6140 SOUTHMOOR DRIVE

GESC Plans

EPC STORMWATER REVIEW COMMENTS
IN ORANGE BOXES WITH BLACK TEXT

COVER SHEET
GESC Plans
6140 SOUTHMOOR DRIVE
FOUNTAIN, COLORADO

COVER SHEET

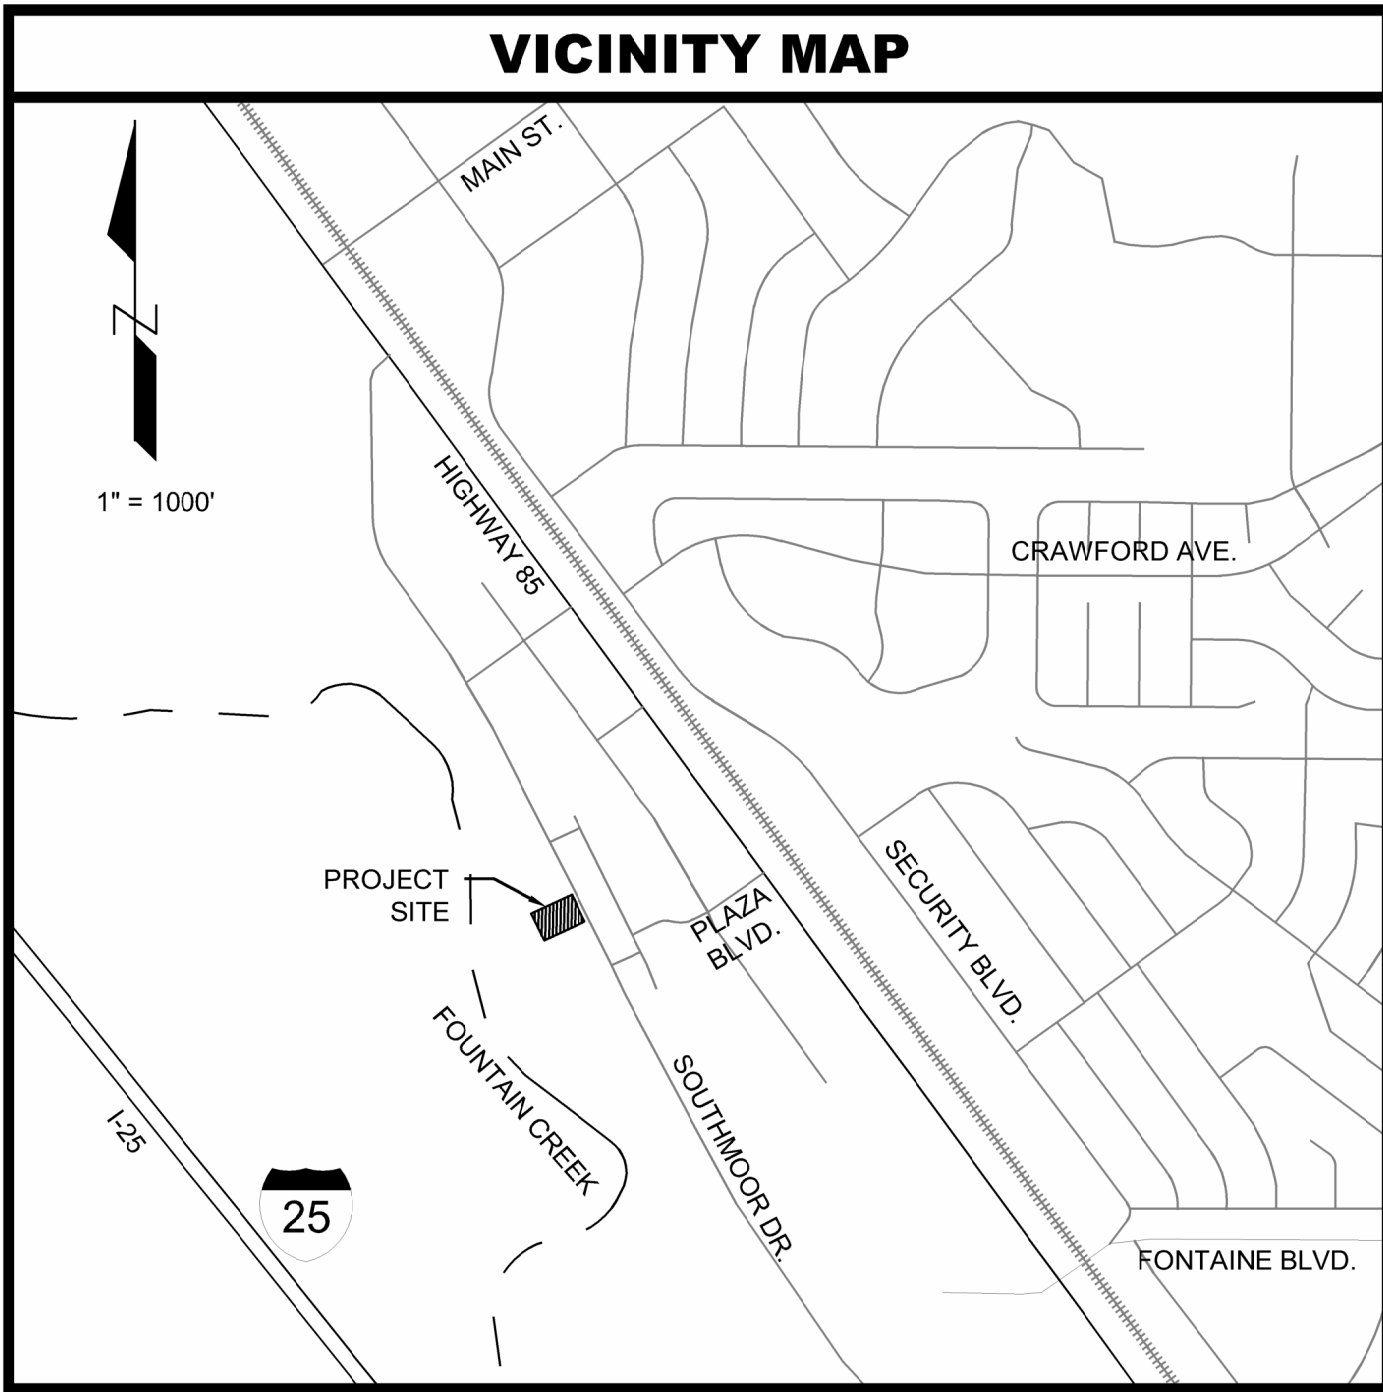
Please replace with EPC Standard Signature Blocks for Grading and Erosion Control Plans.

<https://epc-assets.elpasoco.com/wp-content/uploads/sites/13/Standard-Signature-Blocks-November-2025.doc>

GESC PLAN

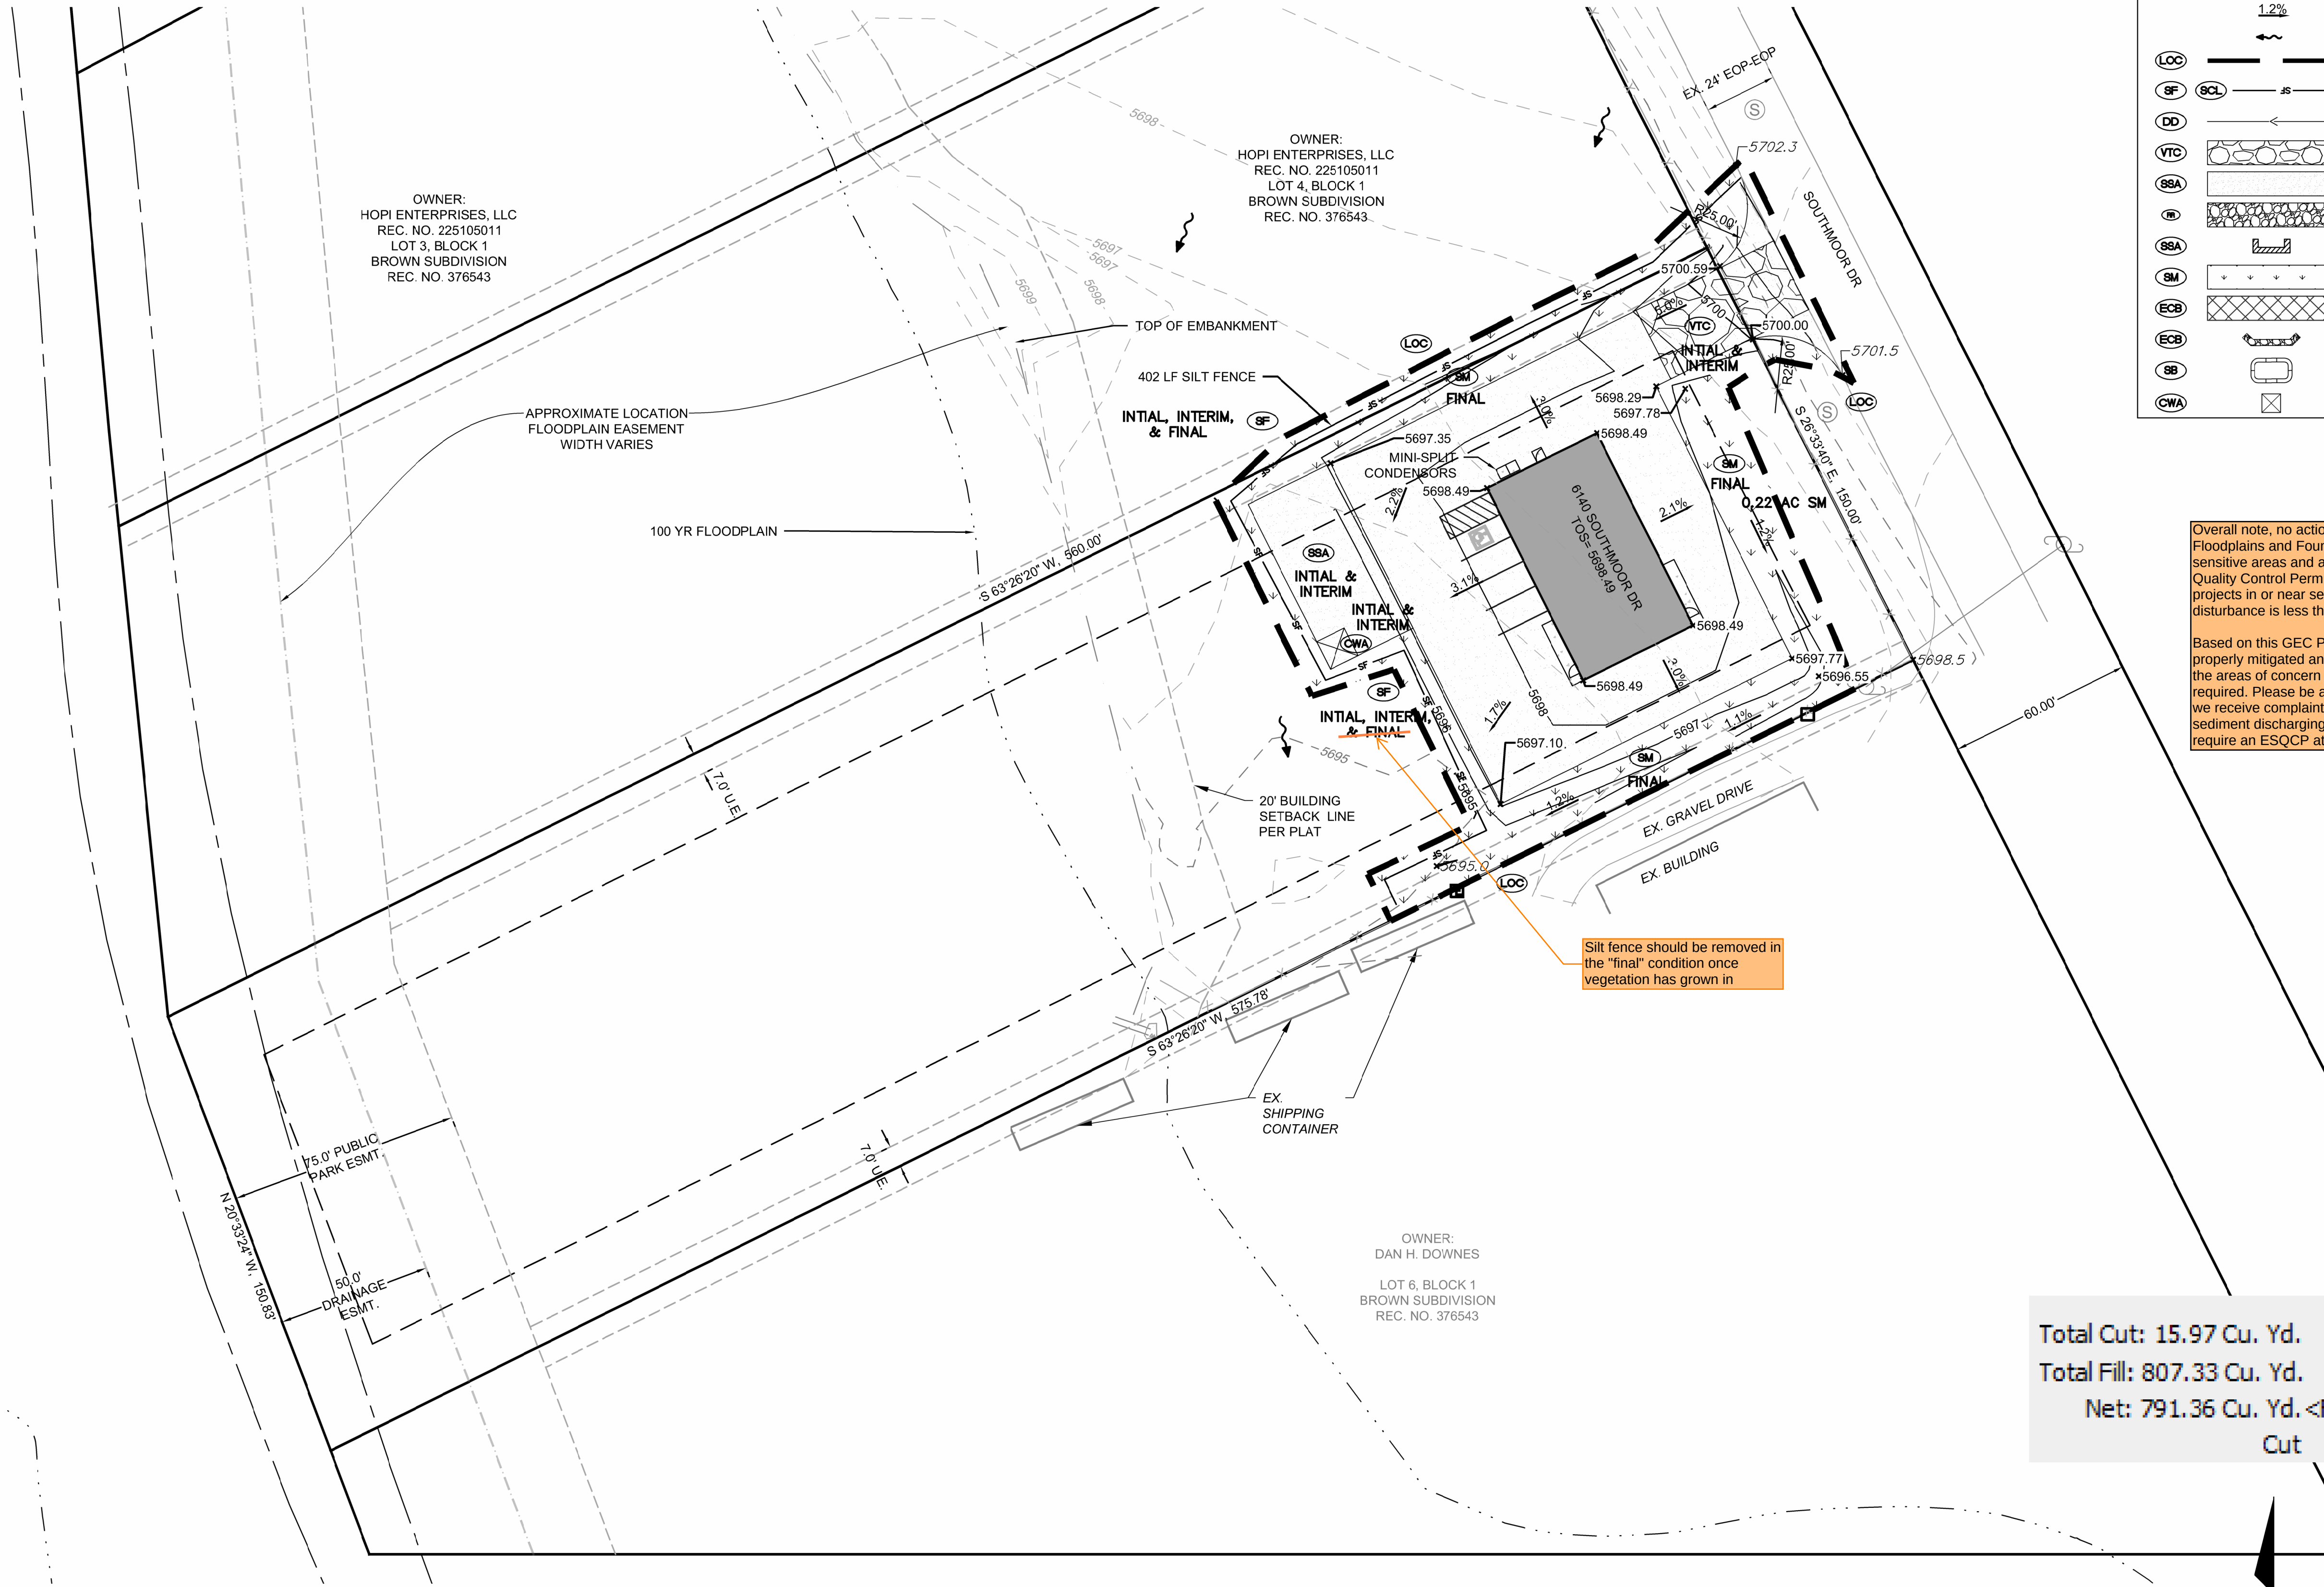
Overall note, no action require at this time: Floodplains and Fountain Creek are considered sensitive areas and an Erosion and Stormwater Quality Control Permit (ESQCP) may be required for projects in or near sensitive areas even if the land disturbance is less than 1 ac.

Based on this GEC Plan this projects disturbance is properly mitigated and located far enough away from the areas of concern that at this time no permit will be required. Please be aware that during construction if we receive complaints about this site or there is sediment discharging into Fountain Creek we can require an ESQCP at that time.
